# Access Compliance Report

## Public Rights-of-Way

Intersection ID: 47230	Main Street: MOREHEAD_MEDICAL_DR	Cross Street: E_MOREHEAD_ST	Location: W
ADA ID: 6DB018DBFB02	Ramp Type: PerpDiag	Initial Pass/Fail: Fail	Overall Compliance: No
Severity Score: 13.75			
Codes/Mitigation Info/Possible Solution		Field Measurements/Component Compliance

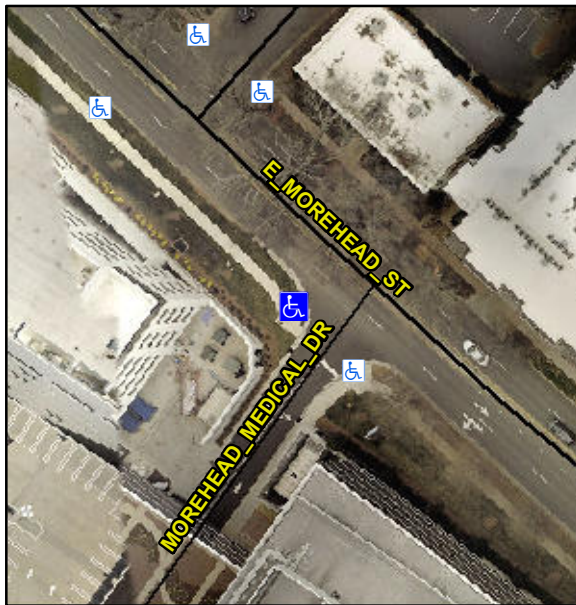
**Not Found, R304.2.2, R304.5.3**

Compliance	Description	Data	Compliance	Description	Data
N/A	Ramp Length (in)	96.0	No	Ramp Slope (%)	9.1
Yes	Ramp Width (in)	49.5	No	Ramp XSlope (%)	2.6
N/A	Flare Type LT	N/A	N/A	Flare Type RT	N/A
N/A	Flare Slope LT (%)	N/A	N/A	Flare Slope RT (%)	N/A
N/A	Flare Traversable LT?	N/A	N/A	Flare Traversable RT?	N/A
N/A	Landing Length (in)	N/A	N/A	DWS Provided?	N/A
N/A	Landing Width (in)	N/A	N/A	DWS Contrast?	N/A
N/A	Landing Slope (%)	N/A	N/A	DWS Length (in)	N/A
N/A	Landing X Slope (%)	N/A	N/A	DWS Full Width?	N/A
N/A	Landing Curb? (Y/N)	N/A	N/A	DWS Offset (in)	N/A
N/A	Shared Landing?	N/A			
N/A	Gutter Ponding?	N/A	N/A	Gutter Slope (%)	N/A
N/A	Gutter Lip Ht (in)	N/A	N/A	Gutter X Slope (%)	N/A
N/A	Painted X Walk1?	No	N/A	Painted X Walk2?	No
	X Walk 1 Direction	To SE		X Walk 2 Direction	To NE
N/A	X Walk 1 Width (in)	N/A	N/A	X Walk 2 Width (in)	N/A
	X Walk 1 Slope (%)	1.0		X Walk 2 Slope (%)	3.1
	X Walk 1 X Slope (%)	4.5		X Walk 2 X Slope (%)	1.8

**Remove & Replace Curb Ramp With Two New Directional Ramps or Equivalent.**
